APPLICATION NO.	FILING DATE	FIRST NAMED INVENTOR	ATTORNEY DOCKET NO.	CONFIRMATION NO.
10/623,749	07/21/2003	Odd N. Oddsen JR.	INNOFF 3.0-024	6349
530	7590	06/13/2006	EXAMINER	
LERNER, DAVID, LITTENBERG, KRUMHOLZ & MENTLIK 600 SOUTH AVENUE WEST WESTFIELD, NJ 07090			CHAN, KO HUNG	
			ART UNIT	PAPER NUMBER
			3632

Office Action Summary	Application No. 10/623,749	Applicant(s) ODDSEN ET AL.	
	Examiner Korie H. Chan	Art Unit 3632

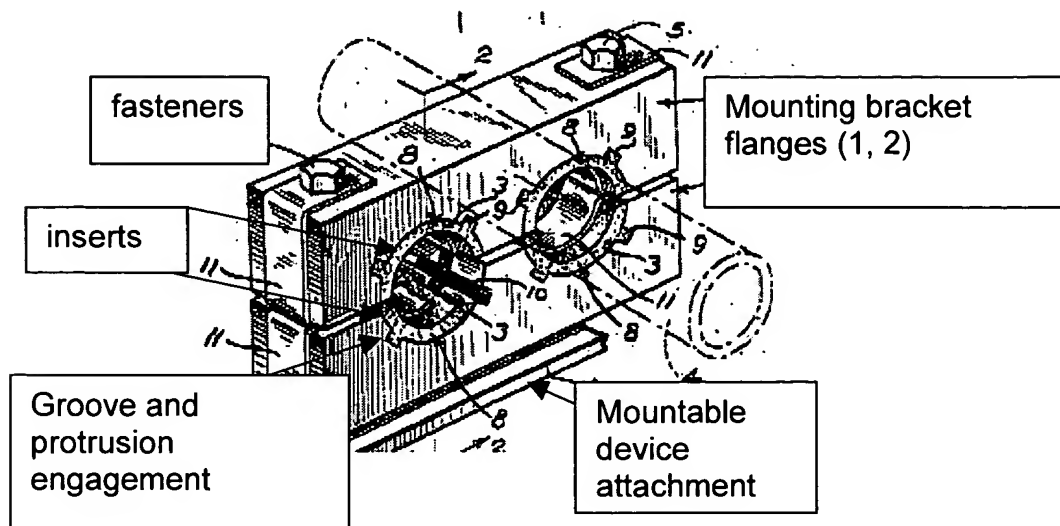
Claims 1-4, 6-9, 18, 21, 22, and 24-30 are rejected under 35 U.S.C. 103(a) as being unpatentable over Morehouse (US patent no. 2,355,742) in view Underwood (UK patent no 2,080,676). Morehouse discloses all the claimed features of applicant's invention (see illustration below) wherein a first predetermined thickness (the thinness part of the insert) defined between the inner and outer surface of one insert is different a second predetermined thickness (the thickness from the inner surface to the outer surface of one of the protrusions of the insert) of another insert (see illustration below).

However Moorehouse does not disclose that the inserts are interchangeable.

Underwood teaches that it is old and well-known to provide plurality of sleeves (inserts 20 and 21, figure 1) with different thicknesses to accommodate different diameter sizes of pipe (page 1, lines 95-98) disposed within an area bound by inner surfaces of a mounting bracket. It would have been obvious to one of ordinary skill in the art to have modify the device of Morehouse such that there are a plurality of inserts provided which are interchangeable to accommodate different diameter sizes of pipes disposed therein as taught to be desirable by Underwood.
